IREDELL COUNTY HEATLH DEPARTMENT

IMPROVEMENT PERMIT / AUTHORIZATION TO CONSTRUCT / OPERATION PERMIT / EXISTING SYSTEM INSPECTION

PERMIT# 065642 PIN# 4625944684 (pt) 4626 20 1059 DATE Jan 17, 02

SUBDIVISION The Harbour BLOCK / SECTION 2 LOT 27 LOT AREA 31,860 ft² SITE CLASS. PS DESIGN FLOW 360 gpd L.T.A.R. .3

INITIAL SITE SKETCH

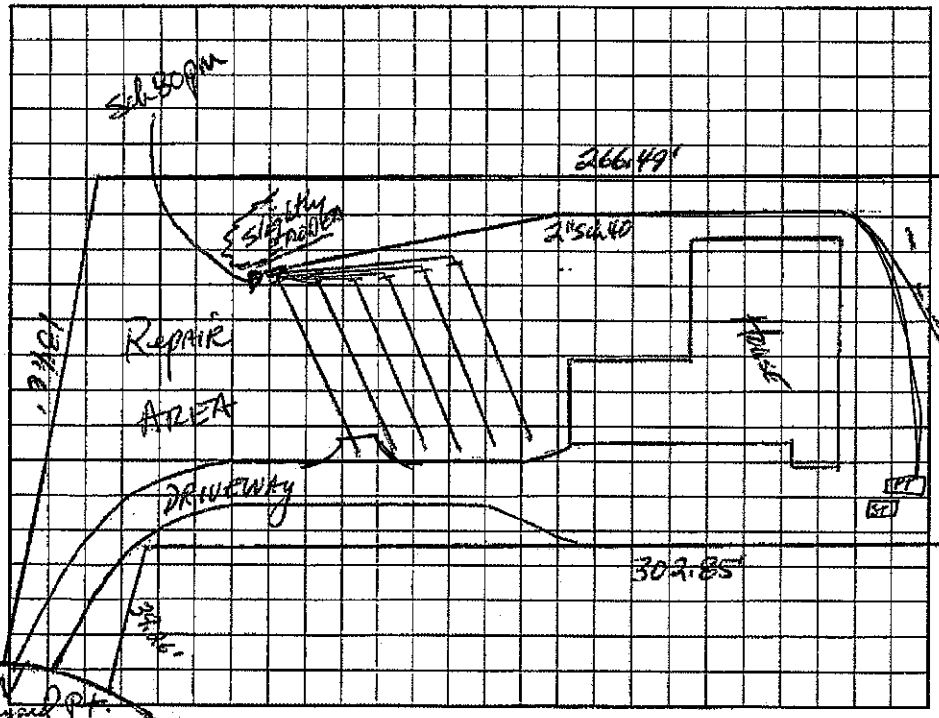
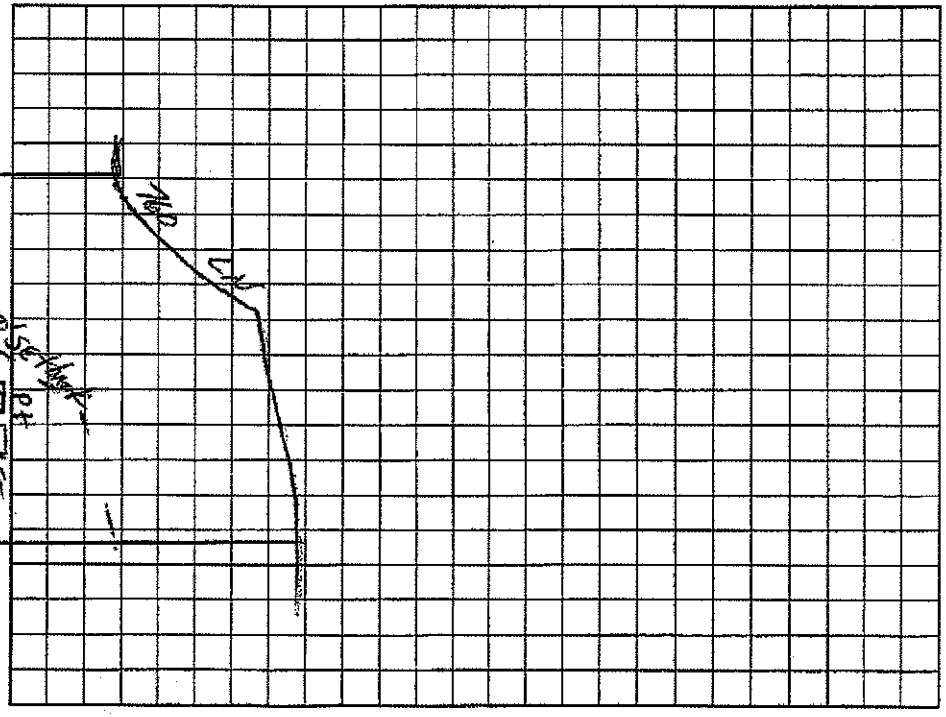
Comments/Conditions:
This permit replaces permit issued 75-01. House was built approx. 15' further upslope and driveway encroached on drainfield necessitating change to 25% Reduction drainfield

Comments/Conditions:
Keep ~~Future~~ sidewalk within 10' of upslope side of garage.
